STAFF RECOMMENDATION

714 Shelby Avenue

April 19, 2017

Application: New construction-infill

Figure 1. 714 Shelby Avenue

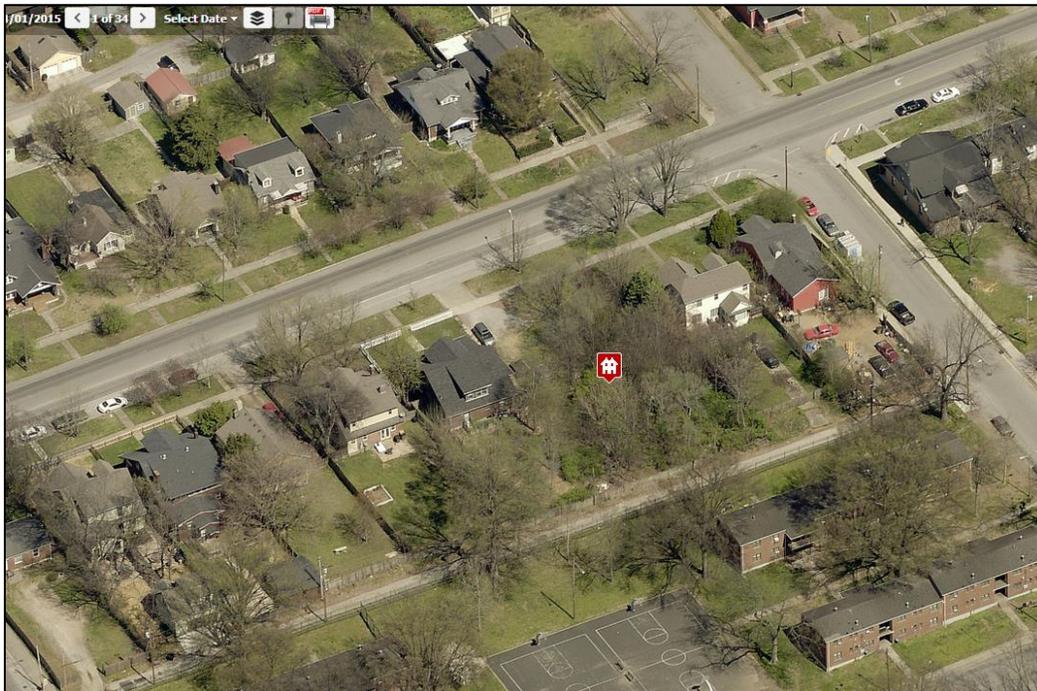
Background: This vacant lot is located at 714 Shelby Avenue (Figure 1).

SITE PLAN

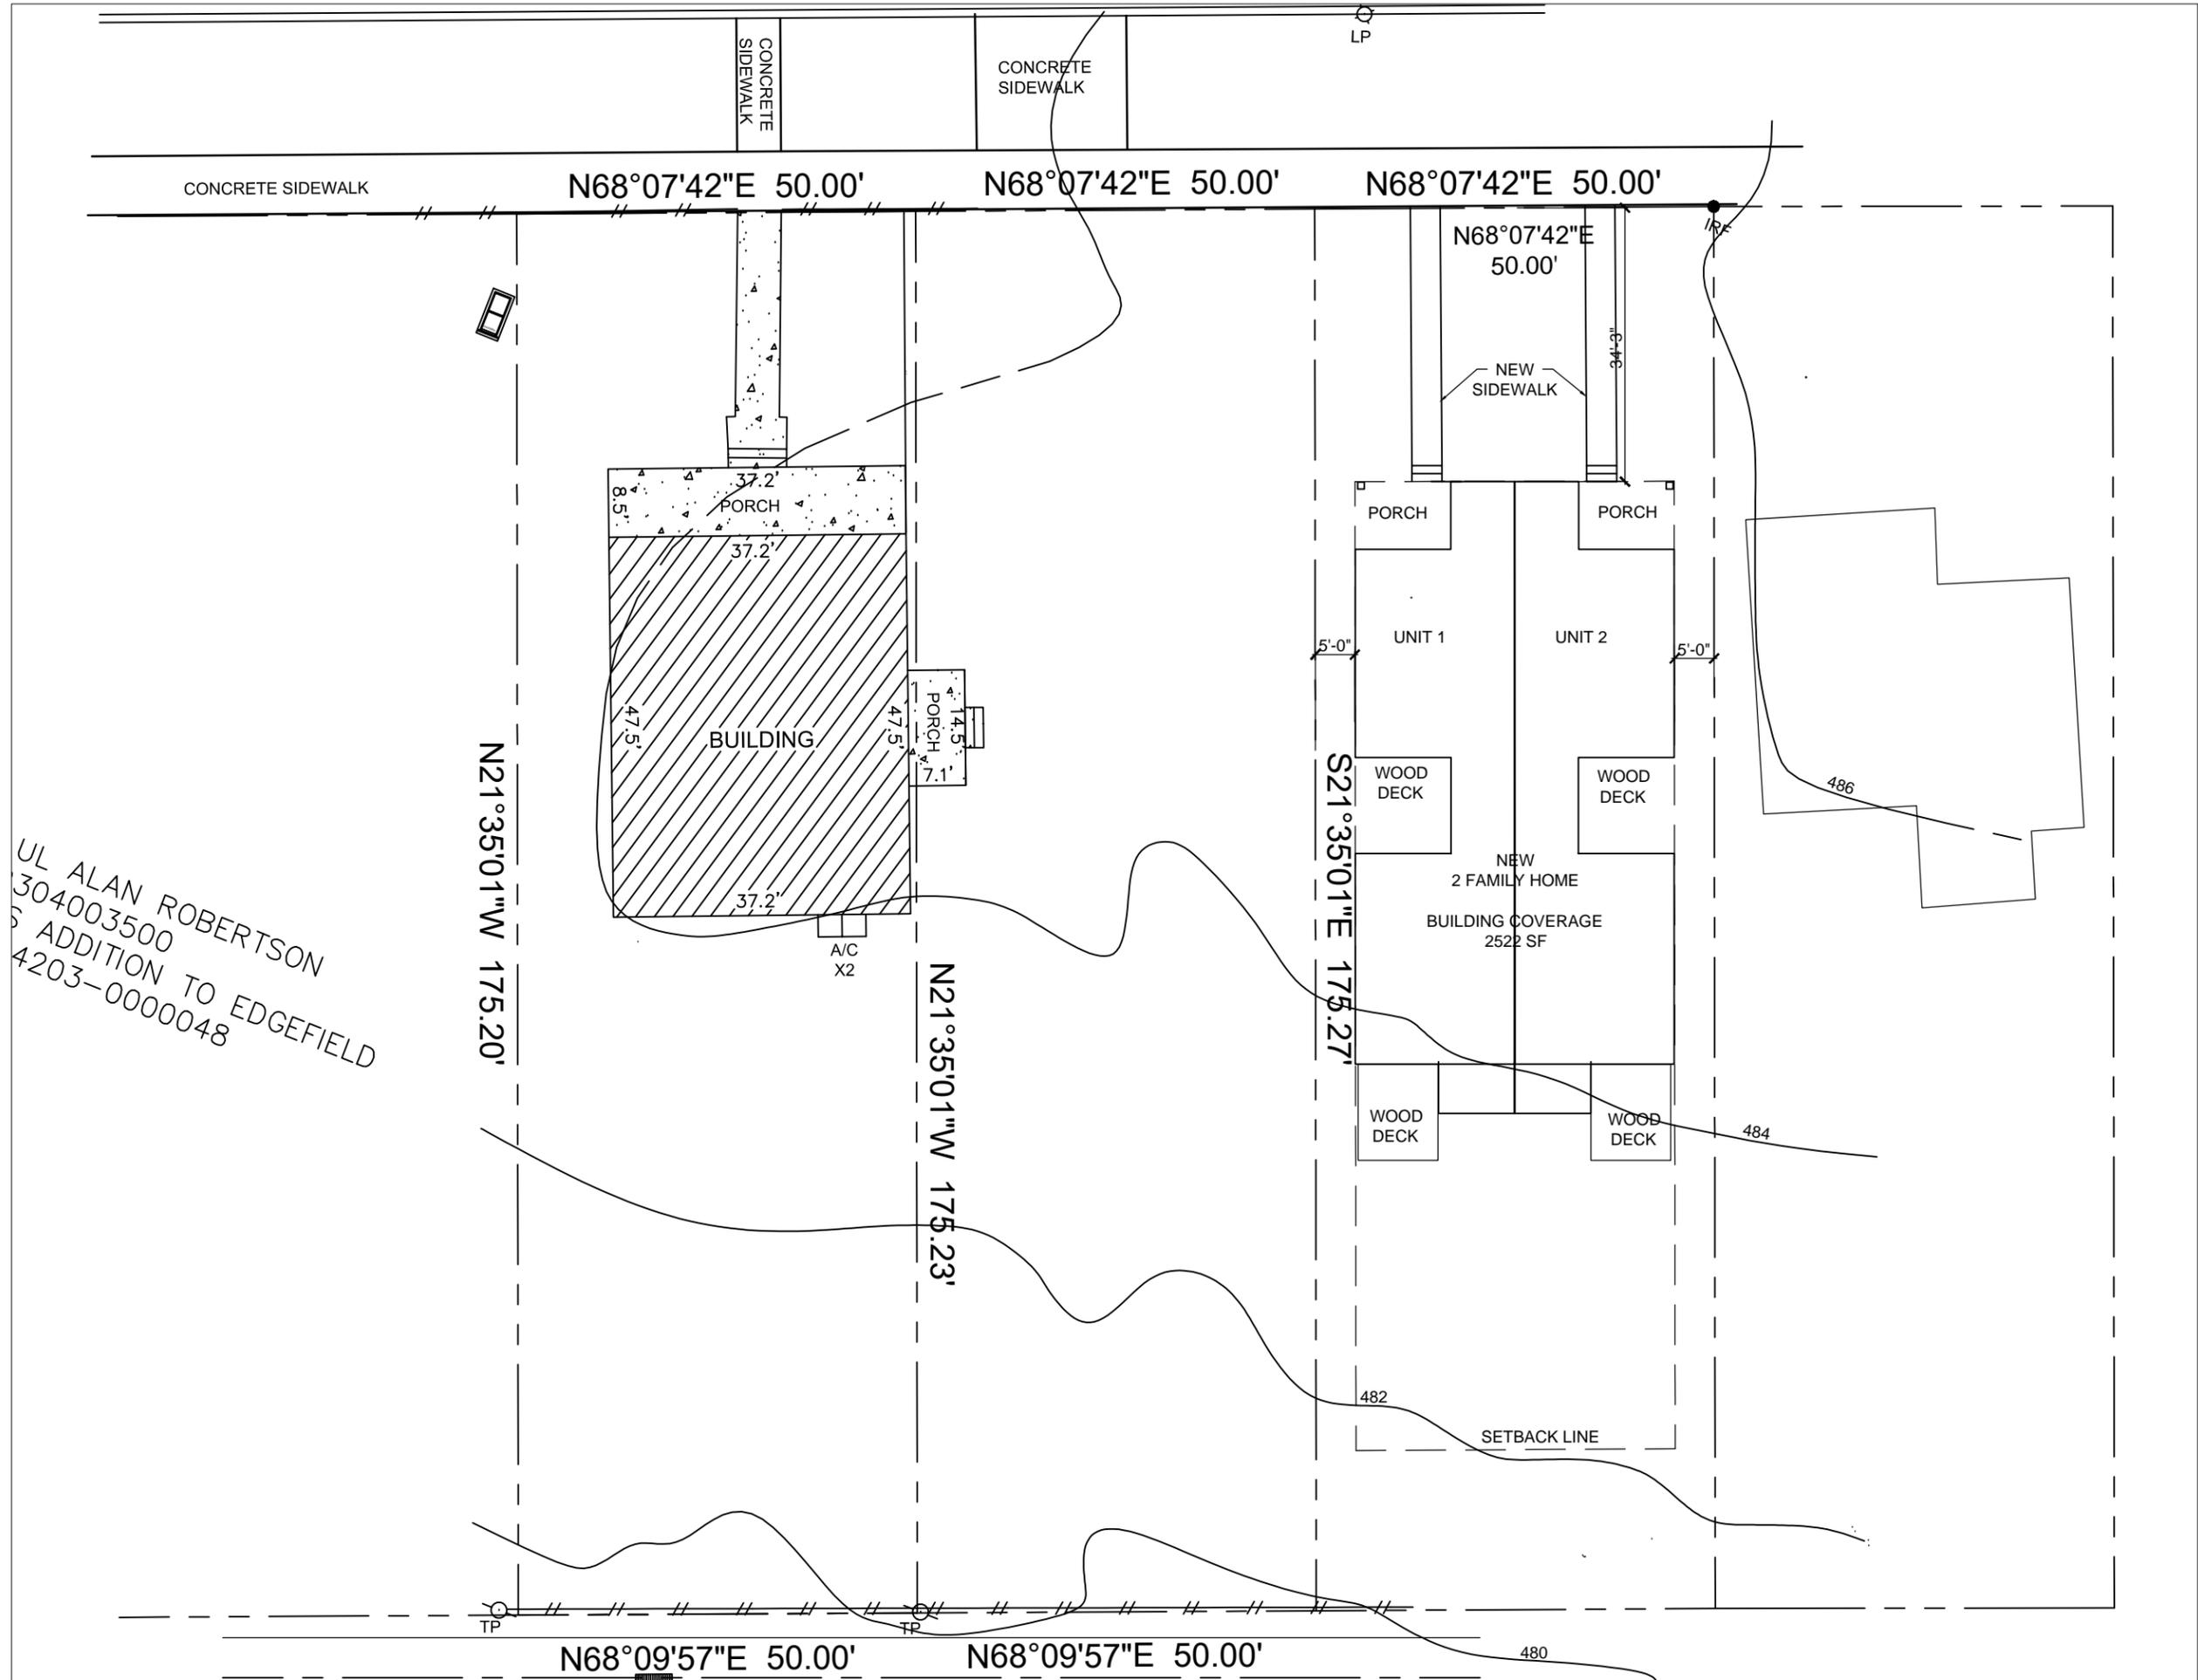
Setback & Rhythm of Spacing: The building is centered on the lot and is proposed at thirty four feet, three inches (34' 3") from the front property line. Recent infill at 712 Shelby was approved in 2016 at thirty-two feet, two inches (32' 2"), matching the historic building to its left. Therefore Staff recommends the new structure match the same

Appurtenances & Utilities: No fencing was included on the site plan. Staff reminds the applicant that all fencing must be reviewed and approved by MHZC. Two walkways will be added from Shelby Avenue to the front porches. The location of the HVAC units and other utilities was not noted. Staff recommends a condition that the HVAC be located on the rear façade, or on a side façade beyond the midpoint of the house. With this condition, the project meets section III.i and IV.1 and 2.

setback. With the condition that the setback matches recently-approved infill next door, and the nearest contributing building, Staff finds the project meets section III.B.2.a for setbacks and rhythm of spacing.

ELEVATIONS

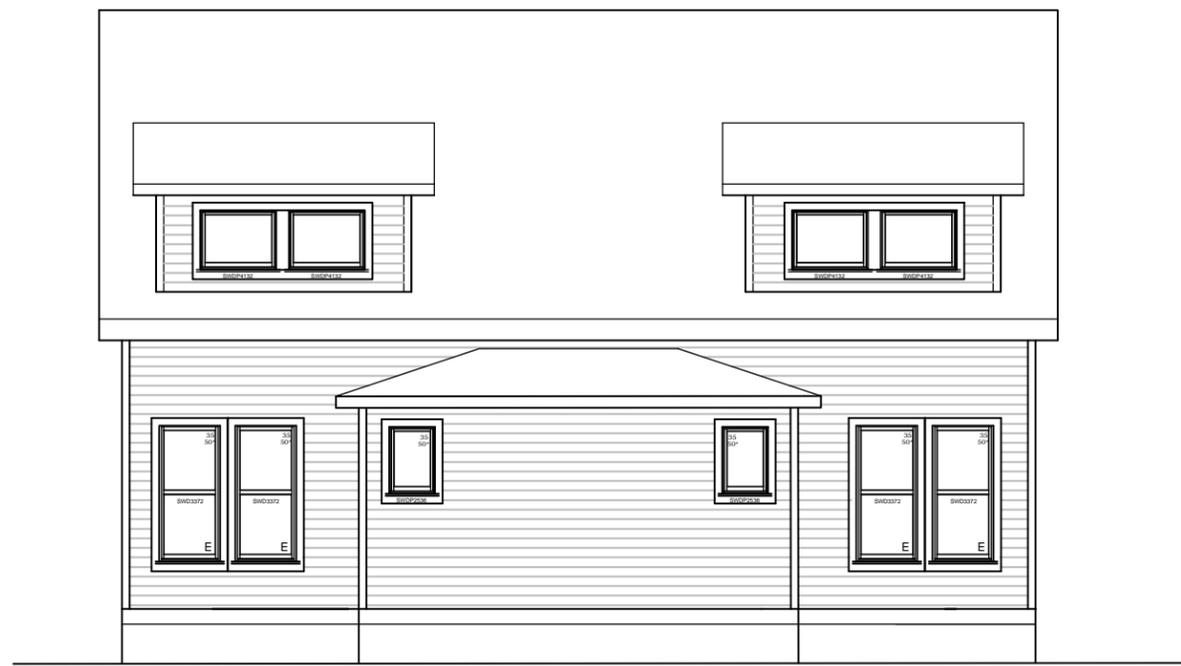
Building and Roof Shape: The building is side gable form with a projecting central bay with a porch on each side of the projection. The porch roof on the front elevation does not match the porch roof shown on the side elevation. In addition, staff has concerns that the front elevation looks more like a secondary entrance with its double doors, possibly flat roof porches, a central projecting bay that does not include a principal entrance or picture-type window, and posts without caps or bases. Staff recommends a redesign of

Proportion and Rhythm of Openings: As mentioned under “Orientation,” the double door front entries are not a typical or an appropriate entry door size for a small 1.5 story duplex. In addition, the windows on the ground floor of the front projecting bay are too small for such a prominent architectural feature and wall. There are multiple solutions such as removing the projecting bay, the front entrances to the bay or larger picture windows.

The remaining windows on the house are generally twice as tall as they are wide, thereby meeting the historic proportion of window openings. There are no large expanses of wall space without a window or door opening. Staff recommends that all paired and triple window openings have a four to six inch (4”-6”) mullion in between them.

the front elevation to have more traditional entry openings, more traditional roof porches, and a more principal façade and for the drawings to be revised to match each other.

With a redesign of the front elevation and the inclusion of four to six inch (4”-6”) mullions on all paired and triple window openings, staff finds the project’s proportion and rhythm of openings to meet Section III.B.2.f. of the design guidelines.

2. Staff recommends a redesign of the front elevation to have more traditional entry openings, more traditional roof porches, and a more principal façade.
3. New drawings be submitted that show the same porch design on both the front and side elevations;
4. All double and triple window openings have a four to six inch (4"-6") mullion in between them;
5. Staff approve the final details, dimensions and materials of windows, doors, roofing color and porch columns prior to purchase and installation;
6. The front setback is moved forward to match recently-approved new construction, and the nearest contributing building;
7. The HVAC shall be located behind the house or on either side, beyond the mid-point of the house.
